PUBLIC UTILITY COMMISSION OF OREGON  
STAFF REPORT  
SPECIAL PUBLIC MEETING DATE: March 16, 2020

**DATE:** February 27, 2020

**FROM:** Caroline Moore

**SUBJECT:** PORTLAND GENERAL ELECTRIC:  
(Docket No. LC 73)  
Acknowledgement of 2019 Integrated Resource Plan

**Figure 1: Renewable Resource Portfolio Additions<sup>84</sup>**

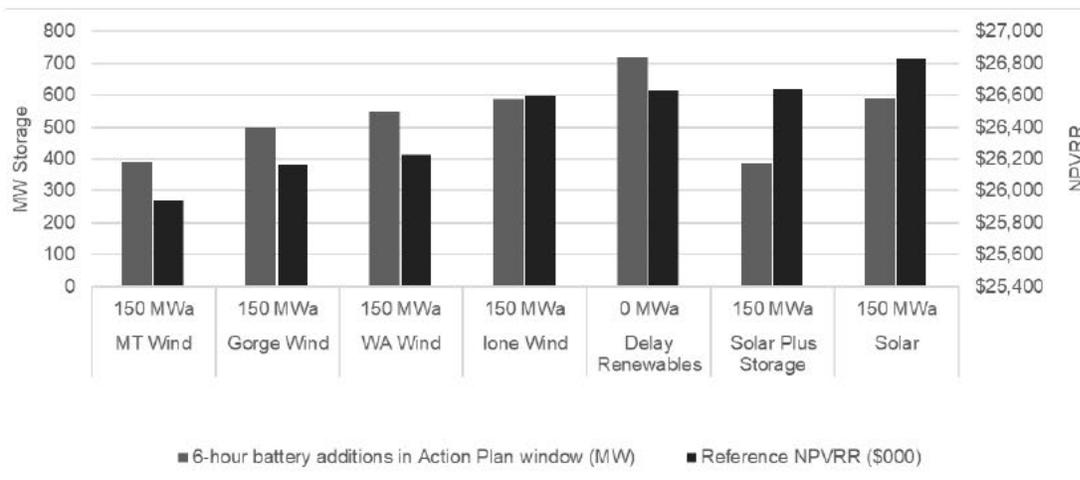
Examination of PGE’s renewable resource portfolios shows that the optimal dispatchable capacity resources—as well as the portfolio’s performance—is closely linked to the attributes of the renewable resources acquired. For example, the portfolio constrained to add 150 MWa of Gorge Wind requires 50 MW fewer in storage capacity additions and provides \$64.5 million of additional benefits compared to adding 150 MWa of Washington Wind.

However, the Washington Wind proxy resource performs notably better than the Gorge Wind on an energy and net resource value basis (roughly 22 percent). This enforces Staff concern that separately pursuing energy resources based on the forecasted energy value places ratepayers at an even higher risk of overbuilding across resources.

**Figure 2: PGE 2017 Proposed Renewable Glide Path**

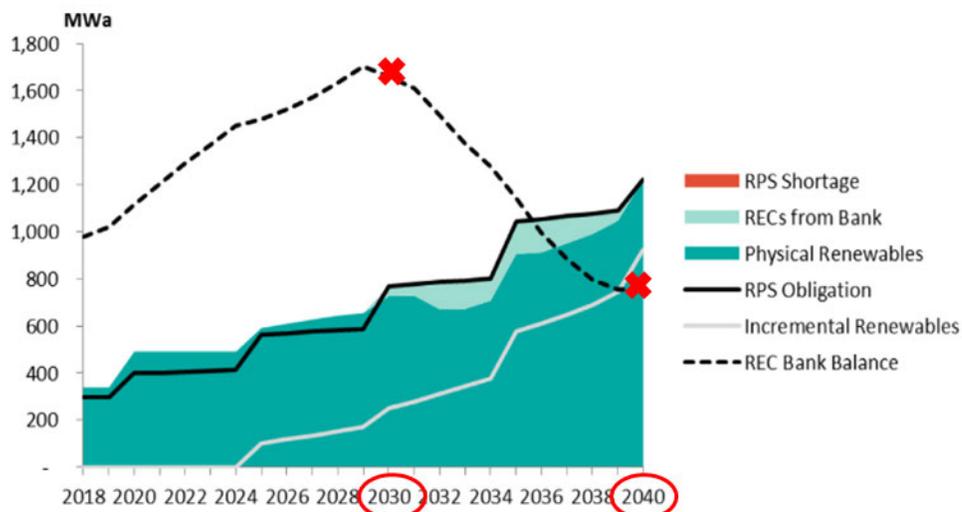
PGE's proposed physical compliance strategy is a large departure from the last IRP. In LC 66, PGE proposed a mix of RECs and near-term resource acquisitions to create a glide path for long-term RPS compliance, as shown in the figure below.<sup>148</sup>

PGE's proposed shift to a physical compliance strategy in the 2019 IRP nearly doubles the forecasted REC bank size by 2030, and by 2040 the REC bank is about seven times larger than the glide path proposed in 2017.<sup>149</sup> For perspective, PGE will have roughly four times as many RECs in its bank than its reference case load forecast in 2040. This means PGE could have enough RECs stored up—already paid for by ratepayers—to meet eight years' worth of its 50 percent RPS obligation.<sup>150</sup>

**Figure 3: PGE 2019 IRP Preferred Portfolio REC Utilization<sup>151</sup>**

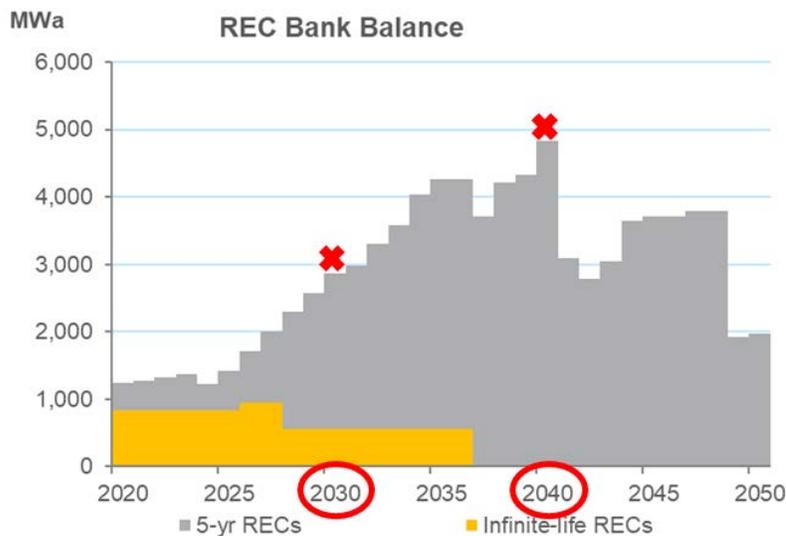
Staff appreciates all of the additional analysis conducted by PGE on issues related to RPS need and its physical compliance strategy. However, we agree with AWEC that this approach overstates the near-term need for PTC wind in an effort to help bolster the more long-term and thus less concrete benefits related to the economic opportunity argument associated with this resource. In this sense, we disagree with the analysis of NWEAC, RNW, and CUB.

PGE presents analysis clarifying that the model can still choose to use banked RECs. However, the physical compliance requirement means that the use of banked RECs cannot actually defer the model's decision to add new resources—it simply determines which RECs are most cost-effective to retire. To this end, if renewables are projected to be so much cheaper than banked or unbundled RECs, then Staff is left wonder why the physical compliance requirement was necessary in the first place.

- Not model a physical compliance requirement in the next IRP;
- Require PGE to model a reasonable amount of banked RECs, like in LC 66, as part of any revised RPS need forecast in upcoming RFPs or the 2019 IRP update;
- Require PGE to model the use up to 20 percent unbundled RECs to meet RPS as part of any revised RPS need forecast in upcoming RFPs or the 2019 IRP update;
- In the next IRP, develop and perform a sensitivity on the preferred portfolio that uses 20 percent unbundled RECs; and
- Open a contested case to determine how to best return value to ratepayers from accumulated unused RECs.

**Figure 4: Historic Commercial and Industrial Load<sup>168</sup>**

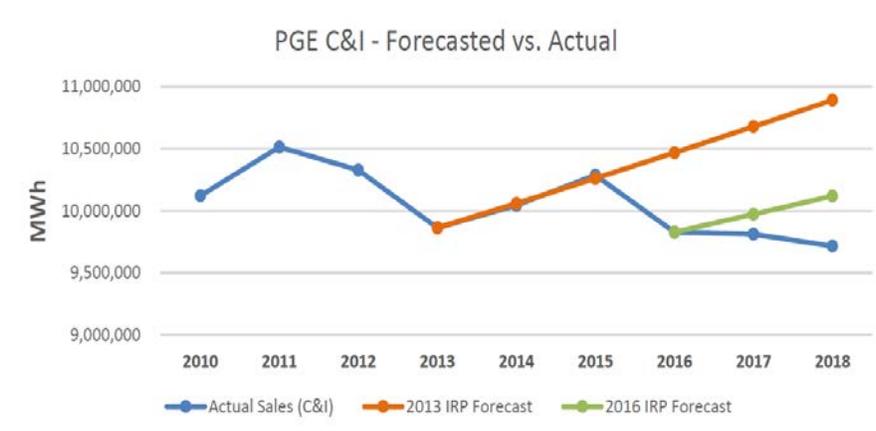
load growth of 0.5 and 1.9 percent for commercial and industrial customers stands in contrast to recently observed annual growth rates.
